## **Technical Bulletin**

## Mitsubishi 4M4# Head Gaskets

## HG1539 vs. HG2258

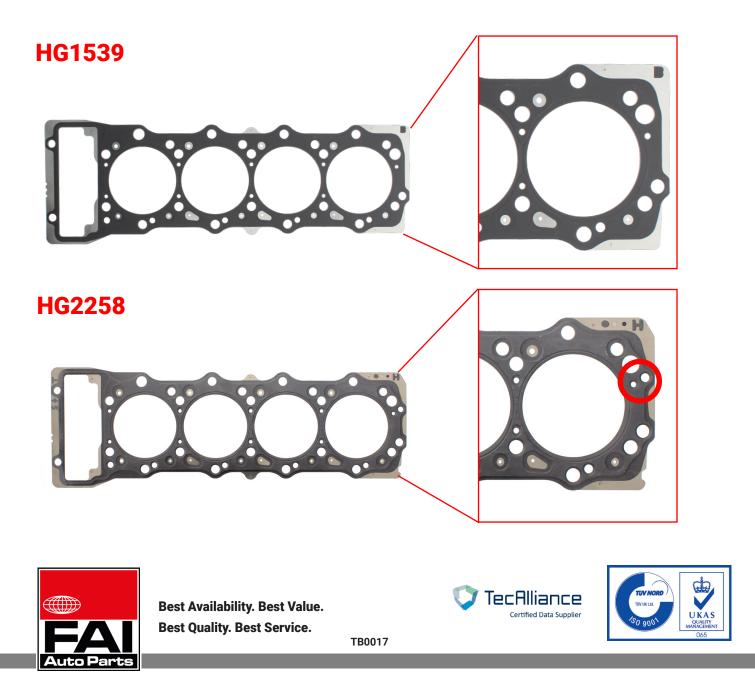
Similarity in gaskets can easily lead to fitment and performance issues. The two gaskets below are a case in point, both fit Mitsubishi four cylinder common rail **4M4#** generation engines. However **HG1539** fits the earlier **3.2 (4M41)** engine, whereas **HG2258** is for the newer **3.0 (4M42-3AT2)** with additional holes.
